| Reference | SSM72808 |
| Models | XE / X760 |
| Title | Diagnosis – XE Scraping/clicking noise when accelerating or cornering |

Cross Brace (to be removed & discarded)

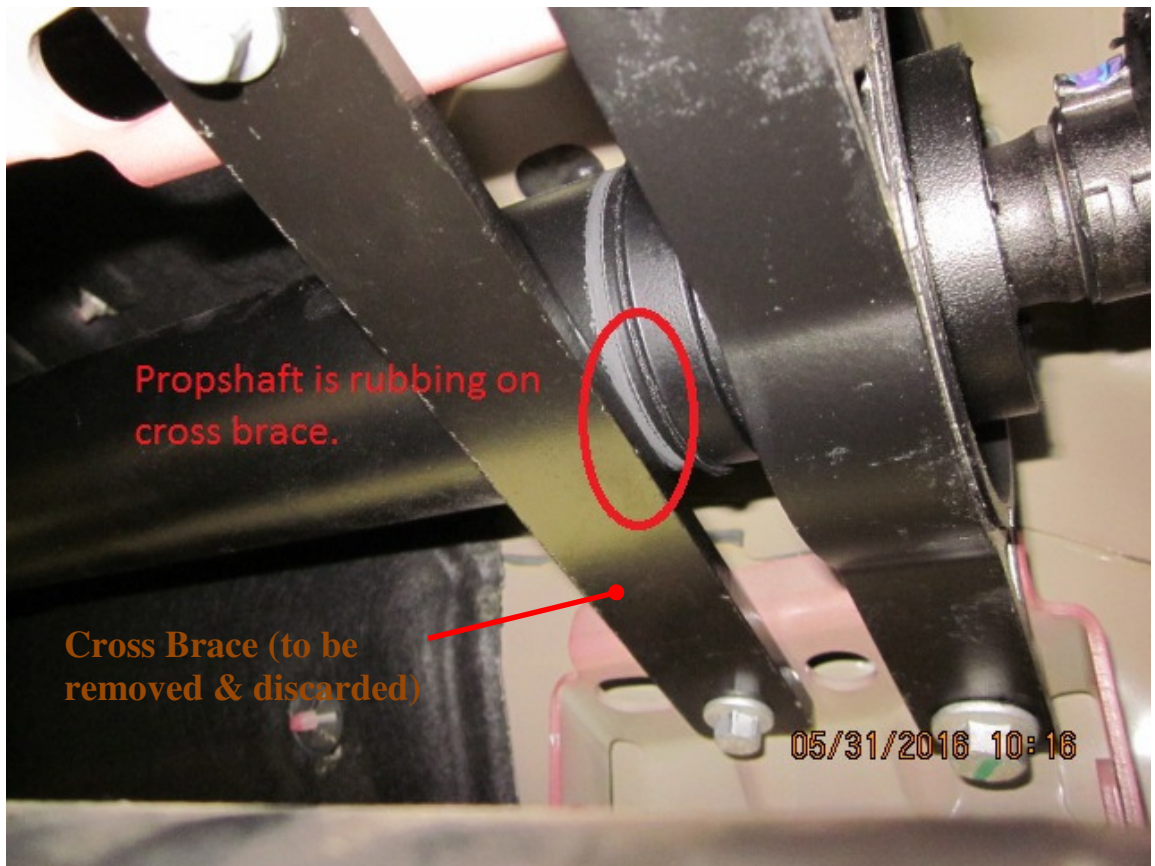
Contact between the underbody cross brace and the driveshaft.

Propshaft is rubbing on cross brace.

- Place the vehicle on a suitable ramp
- Remove the exhaust centre section.
- Remove the heat shield covering the driveshaft centre baring.
- Check a cross brace (as shown in the attachment) is fitted and if so remove and discard.
- Inspect the driveshaft for contact damage this may require replacement if damage is evident.
